From: [Jack Arndt](#)  
 To: [Potala EIS](#); [Teresa Swan](#); [Eric Shields](#); [Kurt Triplett](#); [Robin Jenkinson](#); [Jeremy McMahan](#); [Joan McBride](#); [Doreen Marchione](#); [pswett@kirklandwa.gov](mailto:pswett@kirklandwa.gov); [Dave Asher](#); [Toby Nixon](#); [Bob Sternoff](#); [Mike Miller](#); [Jon Pascal](#); [Jay Arnold](#); [C Ray Allshouse](#); [Byron Katsuyama](#); [Andrew Held](#); [Glenn Peterson](#)  
 Subject: EIS - POTALA VILLAGE  
 Date: Monday, August 20, 2012 3:58:48 PM

I am writing to provide comments regarding the July 12, 2012 draft EIS for the Potala Village Project - City File No. SHR11-00002 and SEP11-00004

FIGURE 3.1-8 MULTIFAMILY DENSITIES

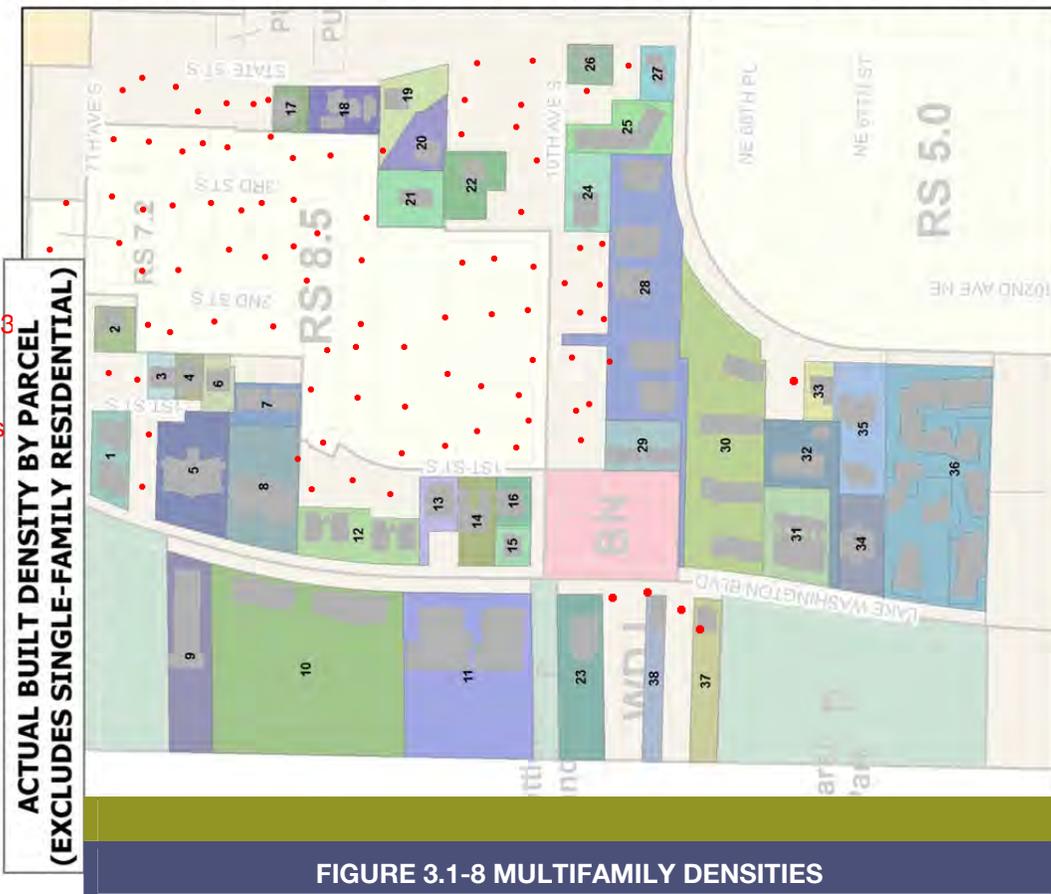
Source: City of Kirkland Zoning Code  
The study area ranges from 1-40 per acre with only 4 of 126 properties being greater than 24/ac. These 4 were built in 1968  
Why ignore single family homes?

5 Whole paragraph is garbage 15 miscalculations in the identified 38 properties 177/acre is actually 40/ac

**FIGURE 3.1-9 STUDY AREA ZONING DESIGNATIONS**

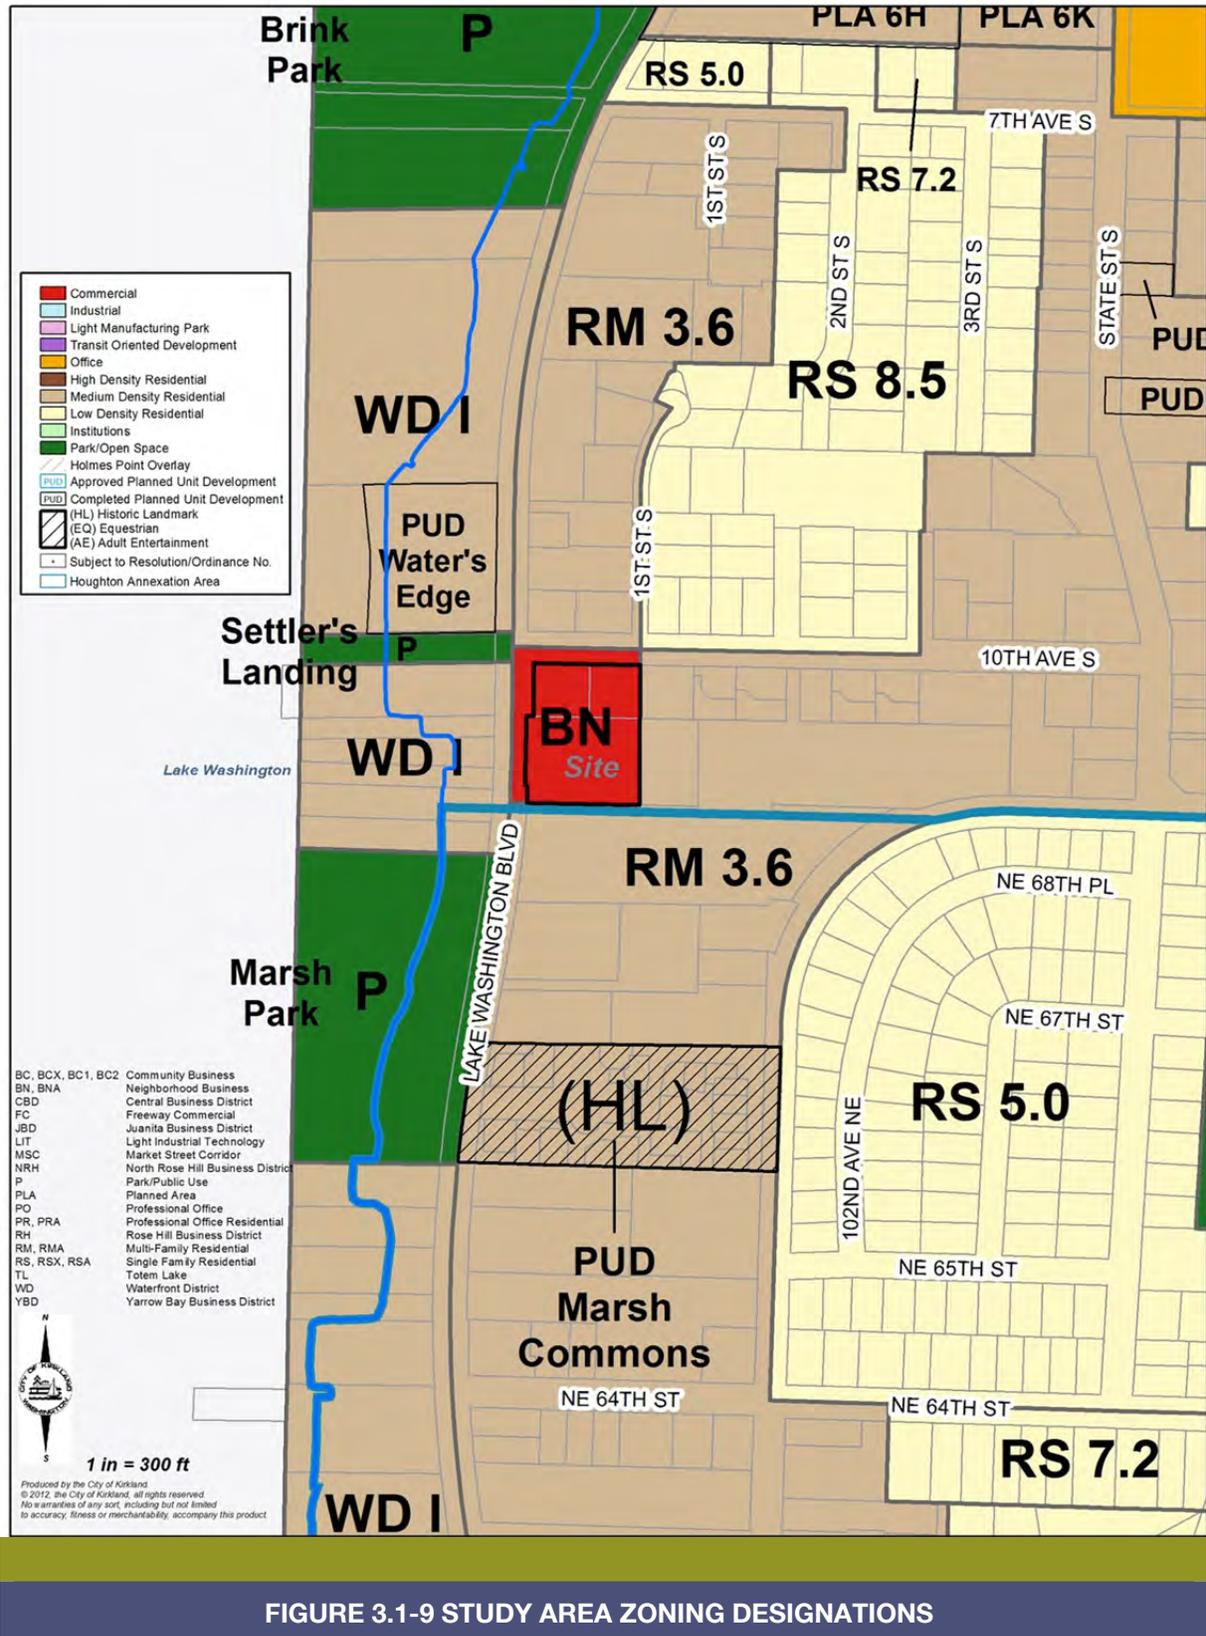
**RM 3.6 and WD 1 zones allow up to 12 units per acre and RS 8.5 allows 5 units per acre. All allow only 60% lot coverage and require significant property line set backs.**

**So how does 118/acre fit? How is 80% lot coverage similar or compatible... especially since it will be built across 3 lots unlike any other building in the area**

FIGURE 3.1-8 MULTIFAMILY DENSITIES

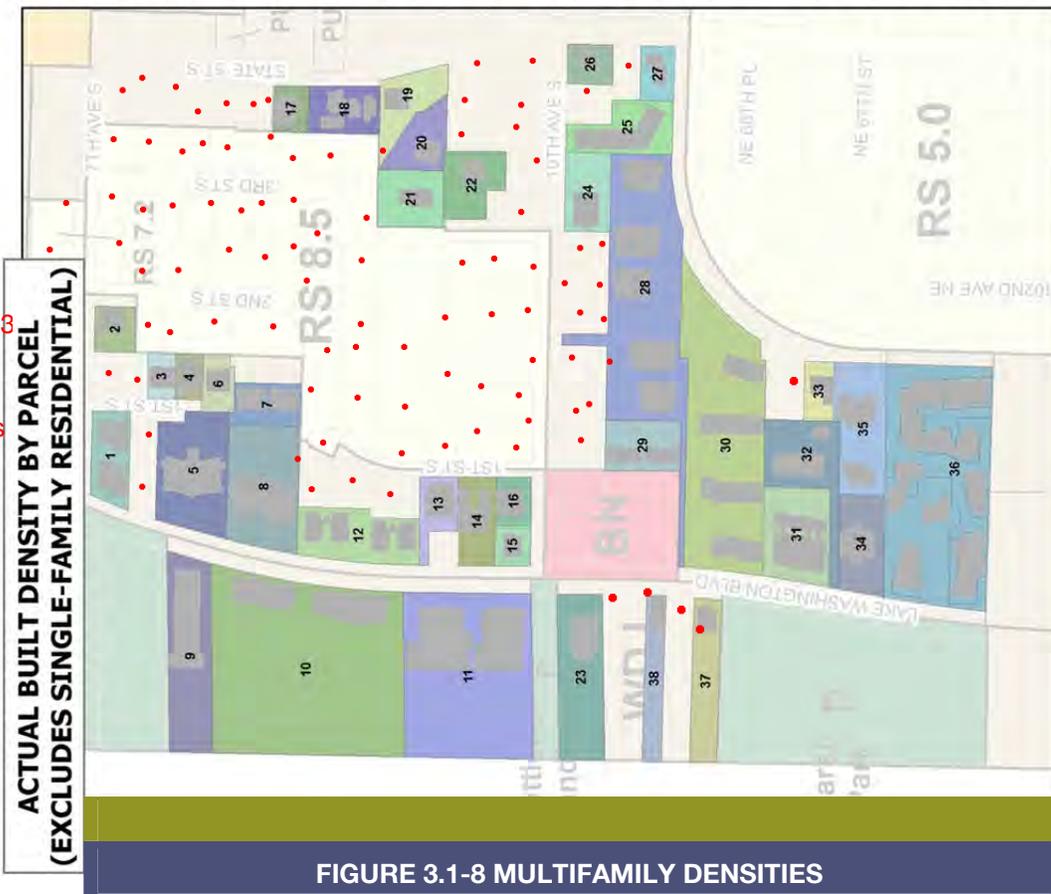
Source: City of Kirkland Zoning Code  
The study area ranges from 1-40 per acre with only 4 of 126 properties being greater than 24/ac. These 4 were built in 1968  
Why ignore single family homes?

5 Whole paragraph is garbage 15 miscalculations in the identified 38 properties 177/acre is actually 40/ac

**FIGURE 3.1-9 STUDY AREA ZONING DESIGNATIONS**

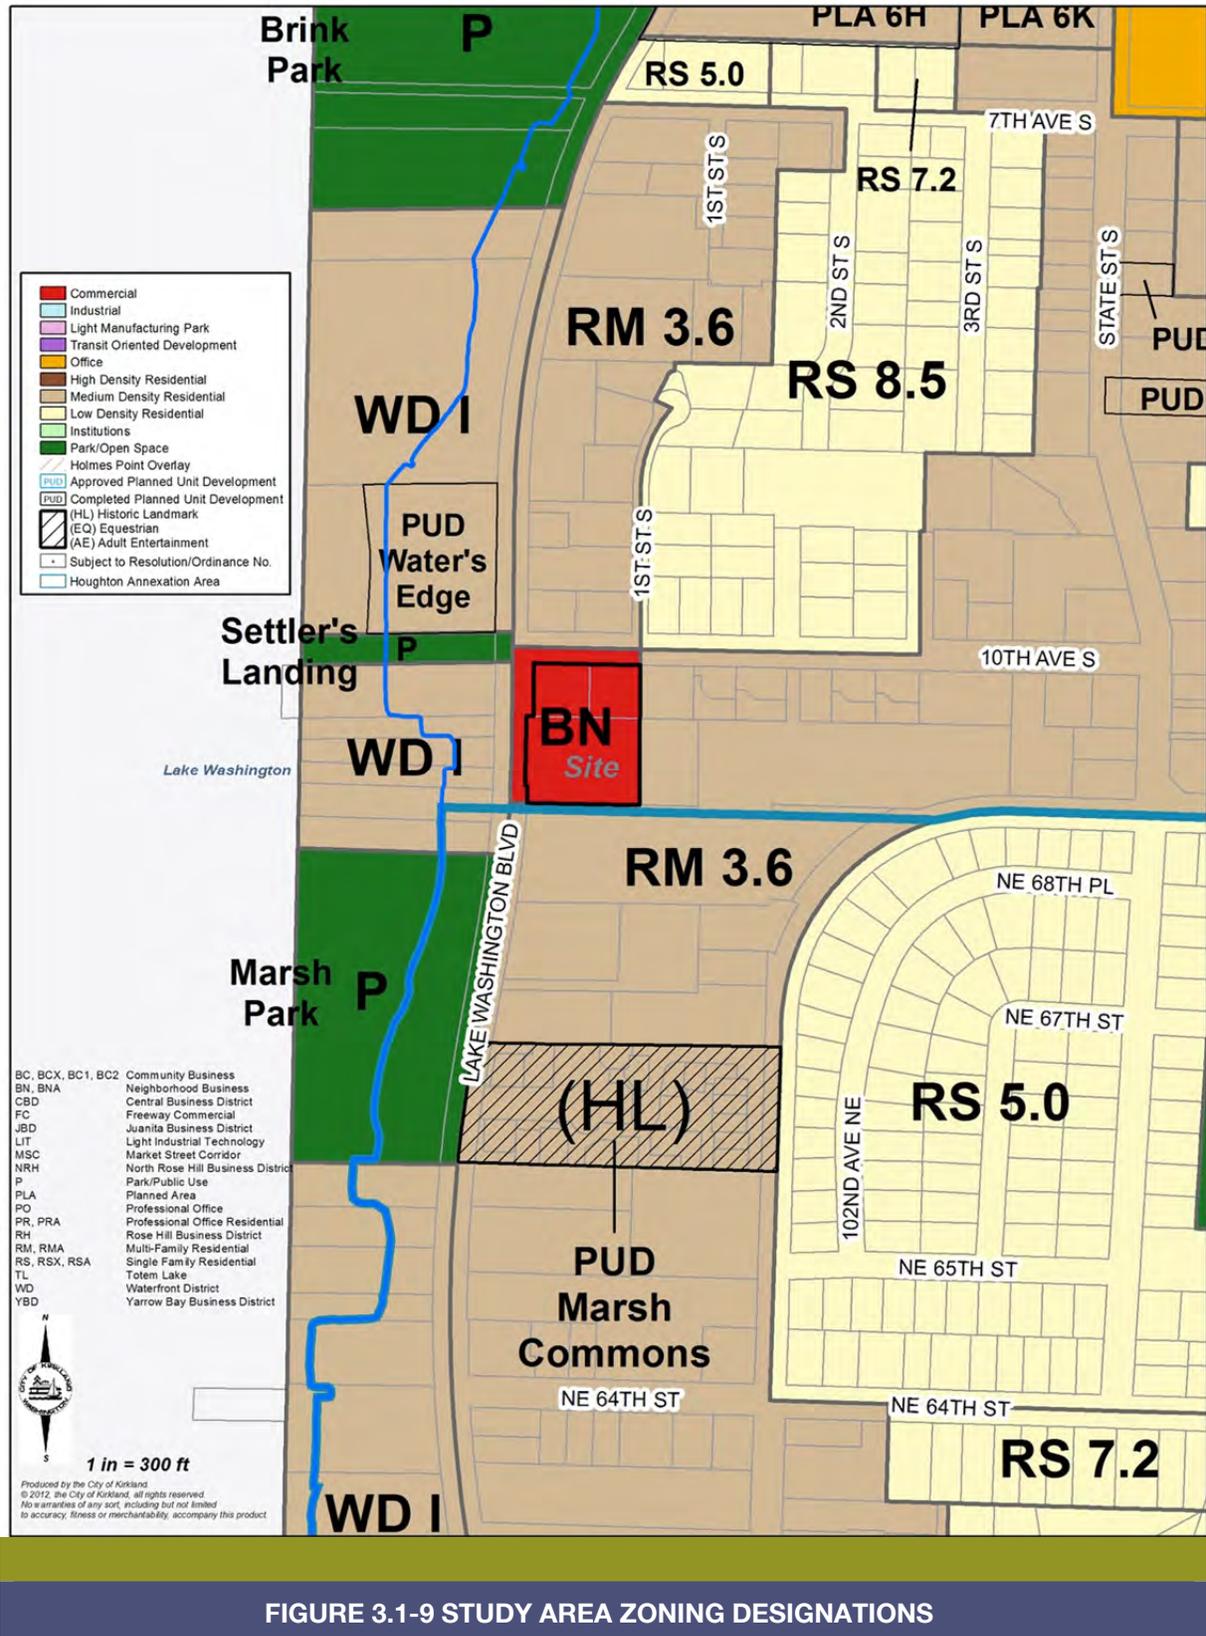
**RM 3.6 and WD 1 zones allow up to 12 units per acre and RS 8.5 allows 5 units per acre. All allow only 60% lot coverage and require significant property line set backs.**

**So how does 118/acre fit? How is 80% lot coverage similar or compatible... especially since it will be built across 3 lots unlike any other building in the area**

FIGURE 3.1-8 MULTIFAMILY DENSITIES

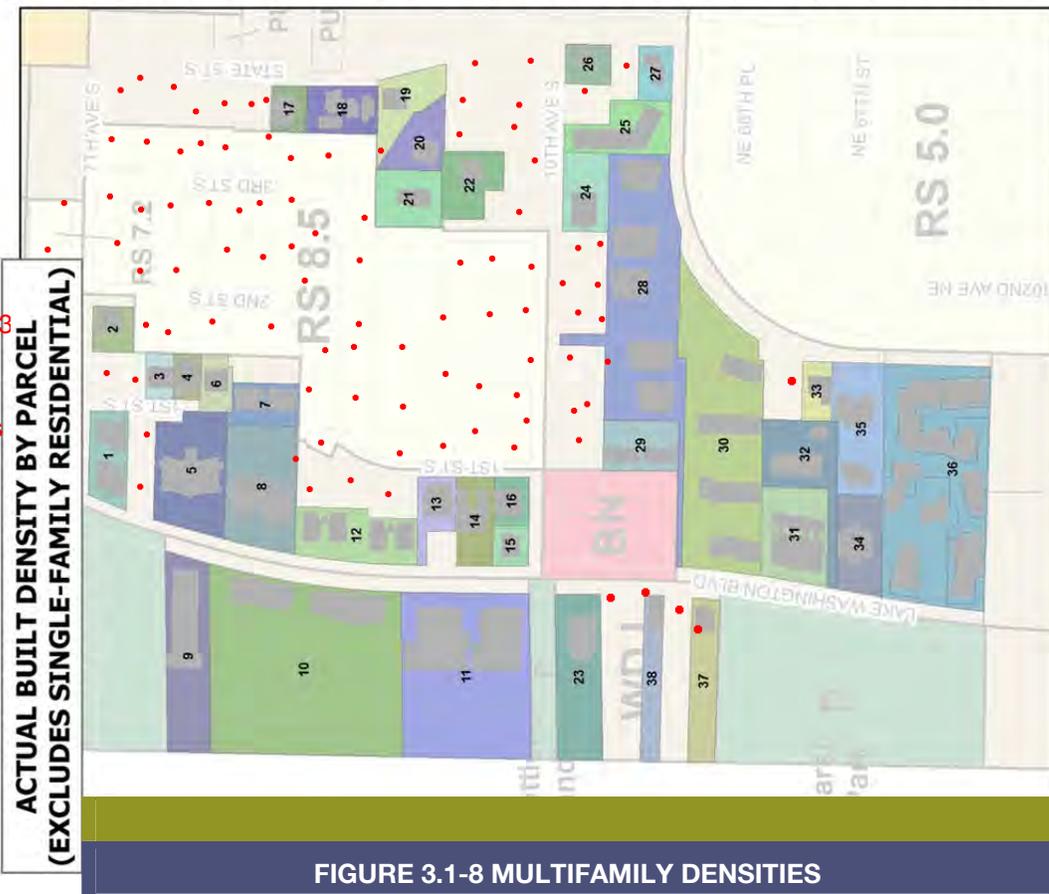
paragraph is garbage 15 miscalculations in the identified 38 properties 177/acre is actually 40/ac

**FIGURE 3.1-9 STUDY AREA ZONING DESIGNATIONS**

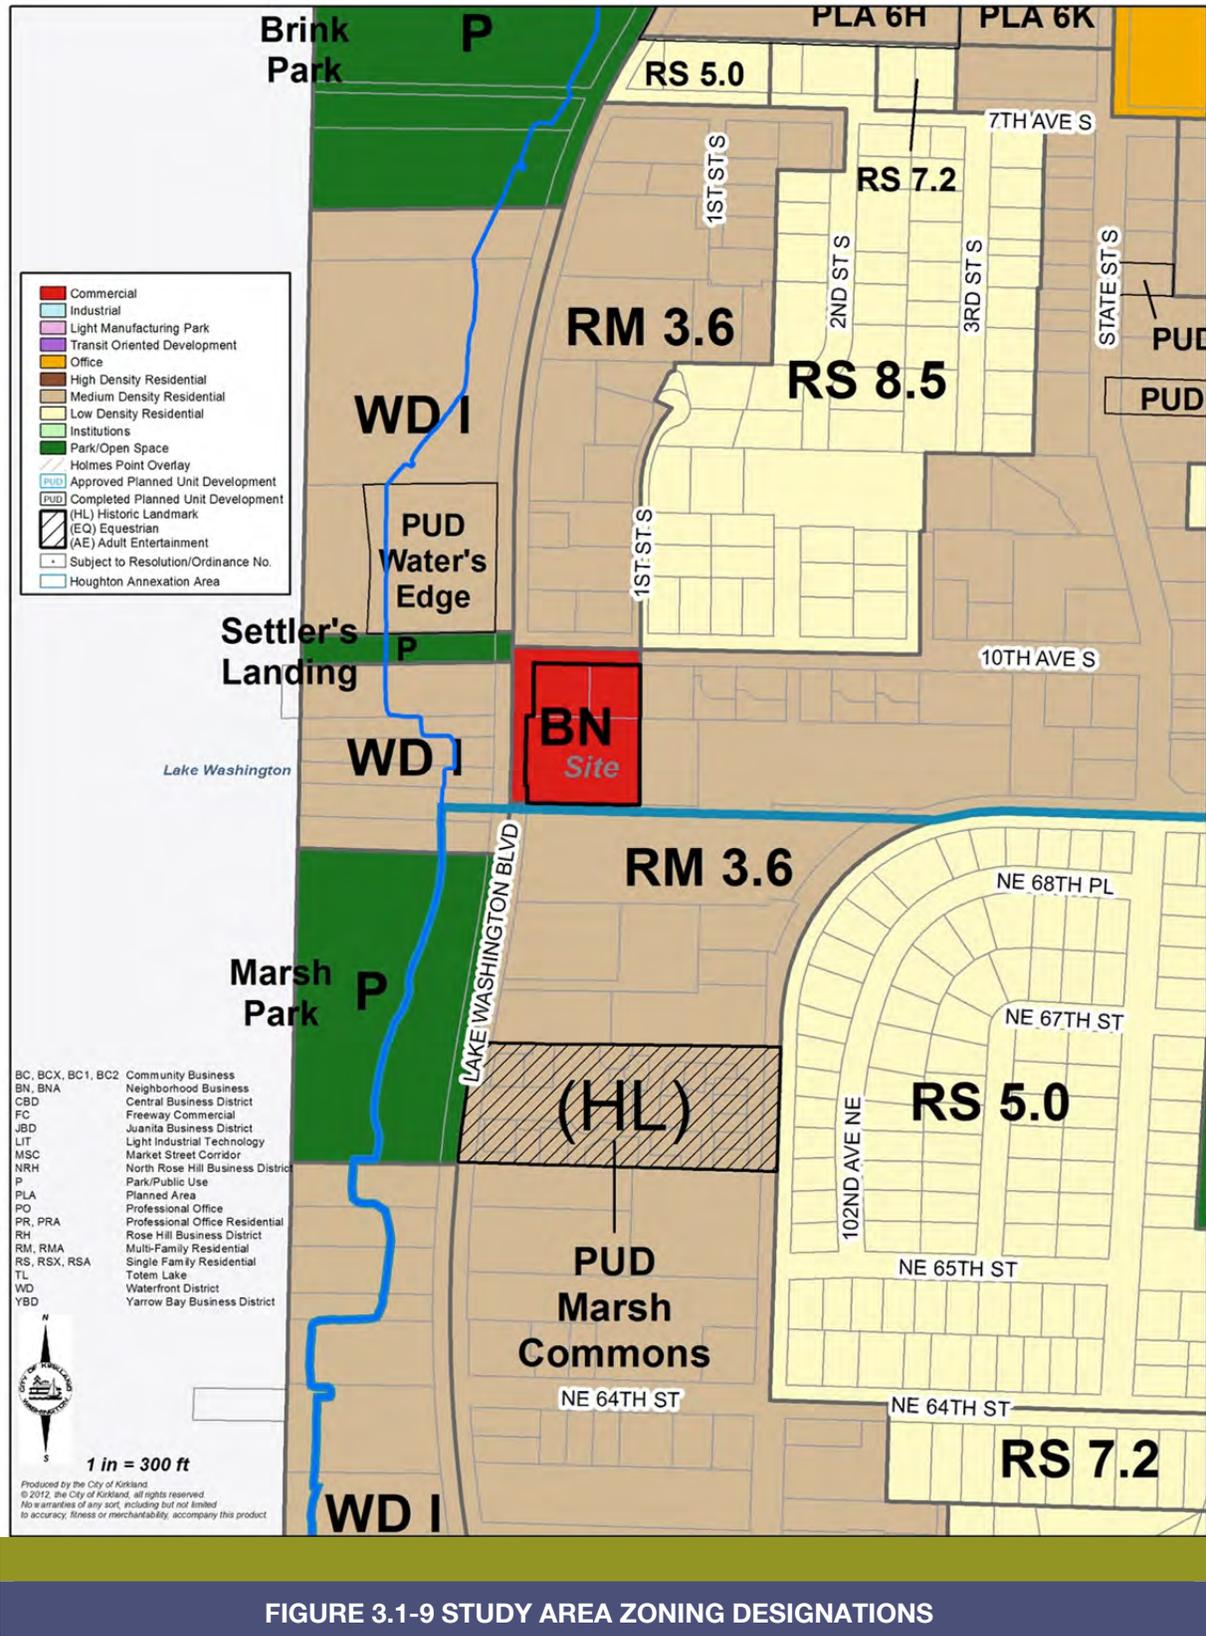
**RM 3.6 and WD 1 zones allow up to 12 units per acre and RS 8.5 allows 5 units per acre. All allow only 60% lot coverage and require significant property line set backs.**

**So how does 118/acre fit? How is 80% lot coverage similar or compatible... especially since it will be built across 3 lots unlike any other building in the area**

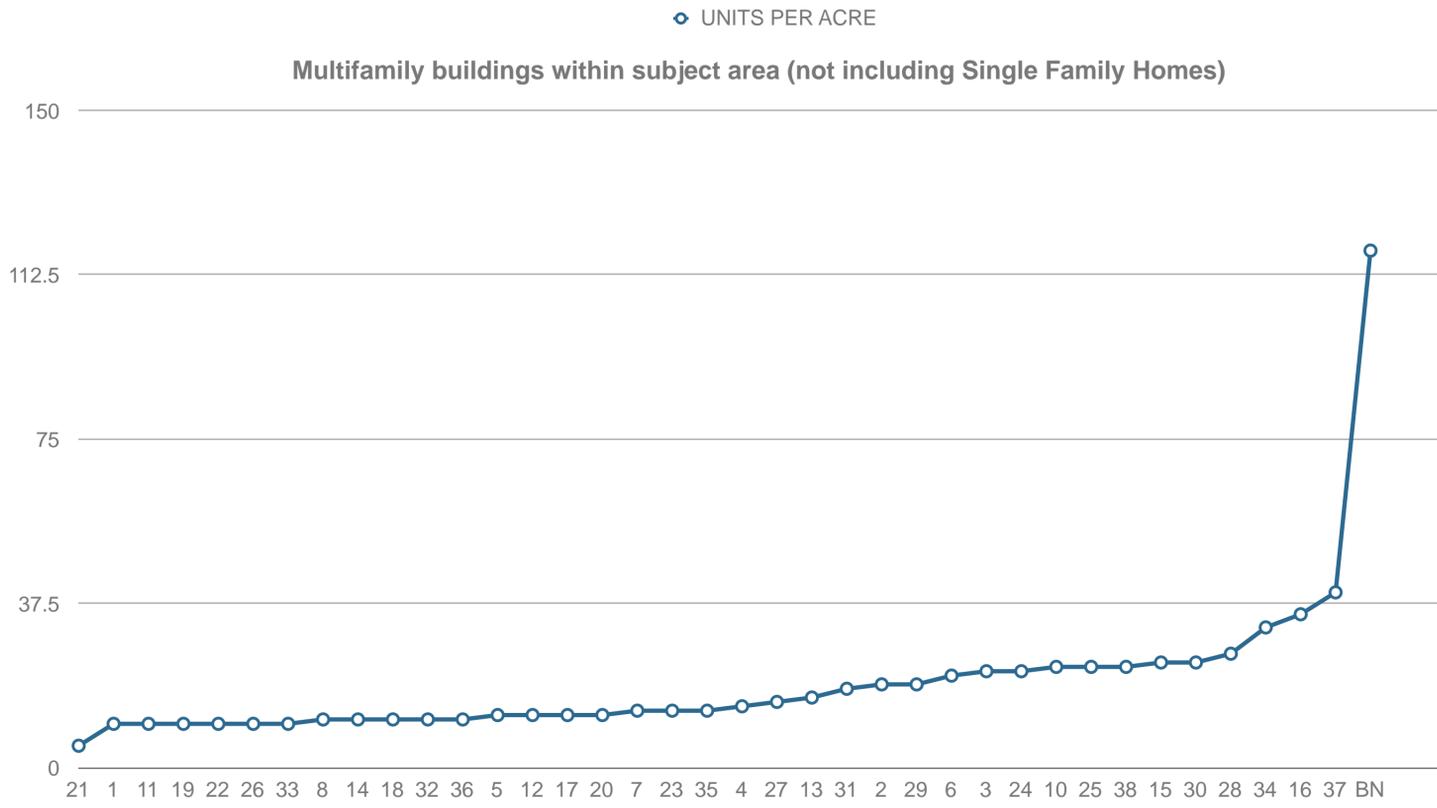
For tonight's meeting and for the record, please look at page two of the attached PDF which shows the SF homes as well as multifamily structures in graphic form. You'll see that everything currently built, whether multifamily or single family is in a relative range but then there is a massive spike upwards when a 118unit/acre proposal is added. We believe that this type of evidence shows that the DEIS is either very flawed or biased. The spike is not at all consistent with the surrounding land use as the consultants state.
